# UNITED STATES PATENT AND TRADEMARK OFFICE

APPLICATION NO.	FILING DATE	FIRST NAMED INVENTOR	ATTORNEY DOCKET NO.	CONFIRMATION NO.
10/783,549	02/20/2004	Christopher L. Johnson	21029.29003	7422

## Office Action Summary

## **DETAILED ACTION**

FIG. 1

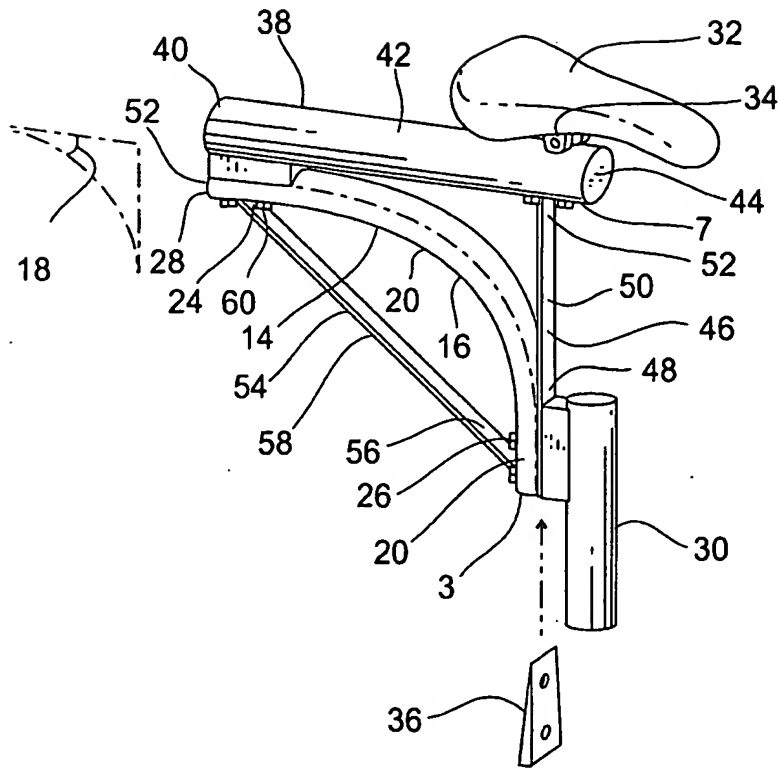
- Reference numbers "10, 12 and 22" are not in the drawings.
- Reference numbers "1, 3, 4, 5, 7 and 16" are not mentioned in the specification.
- Reference number "52" on the left of figure 1 needs to be deleted.
- In figures 1 and 2, contoured flat springs 14 do not look flat. In fact, they look like having circular cross sections.
- There is not a description of figure 2 in the specification.

NOT approved

Corrected drawing sheets in compliance with 37 CFR 1.121(d), or amendment to the specification to add the reference character(s) in the description in compliance with 37 CFR 1.121(b) are required in reply to the Office action to avoid abandonment of the application. Any amended replacement drawing sheet should include all of the figures appearing on the immediate prior version of the sheet, even if only one figure is being amended. Each drawing sheet submitted after the filing date of an application must be labeled in the top margin as either "Replacement Sheet" or "New Sheet" pursuant to 37 CFR 1.121(d). If the changes are not accepted by the examiner, the applicant will be notified and informed of any required corrective action in the next Office action. The objection to the drawings will not be held in abeyance.
